# Access Compliance Report

## Public Rights-of-Way

### (Curb Ramps)

Intersection ID: 50664	Main Street: WITHERS_RD	Cross Street: CRAIGHILL_LN	Location: NW
ADA ID: BFA34878A14C	Ramp Type: Perp	Initial Pass/Fail: Fail	Overall Compliance: No
Severity Score: 12.5			
Codes/Mitigation Info/Possible Solution		Field Measurements/Component Compliance

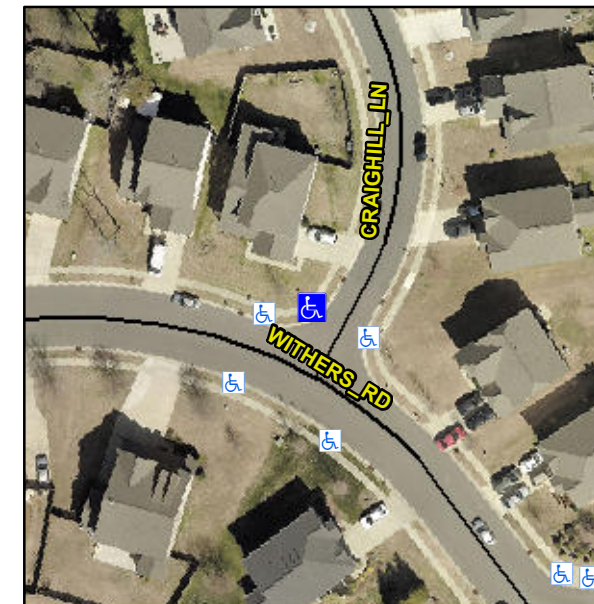
Compliance	Description	Data	Compliance	Description	Data
N/A	Ramp Length (in)	48.0	No	Ramp Slope (%)	8.7
Yes	Ramp Width (in)	48.0	Yes	Ramp XSlope (%)	0.3
N/A	Flare Type LT	N/A	N/A	Flare Type RT	N/A
N/A	Flare Slope LT (%)	N/A	N/A	Flare Slope RT (%)	N/A
N/A	Flare Traversable LT?	N/A	N/A	Flare Traversable RT?	N/A
N/A	Landing Length (in)	N/A	N/A	DWS Provided?	N/A
N/A	Landing Width (in)	N/A	N/A	DWS Contrast?	N/A
N/A	Landing Slope (%)	N/A	N/A	DWS Length (in)	N/A
N/A	Landing X Slope (%)	N/A	N/A	DWS Full Width?	N/A
N/A	Landing Curb? (Y/N)	N/A	N/A	DWS Offset (in)	N/A
N/A	Shared Landing?	N/A			
N/A	Gutter Ponding?	N/A	N/A	Gutter Slope (%)	N/A
N/A	Gutter Lip Ht (in)	N/A	N/A	Gutter X Slope (%)	N/A
N/A	Painted X Walk1?	No	N/A	Painted X Walk2?	N/A
	X Walk 1 Direction	To SE		X Walk 2 Direction	N/A
N/A	X Walk 1 Width (in)	N/A	N/A	X Walk 2 Width (in)	N/A
	X Walk 1 Slope (%)	0.5		X Walk 2 Slope (%)	N/A
	X Walk 1 X Slope (%)	3.8		X Walk 2 X Slope (%)	N/A

**Remove & Replace Entire Ramp.**

**R304.2.2**
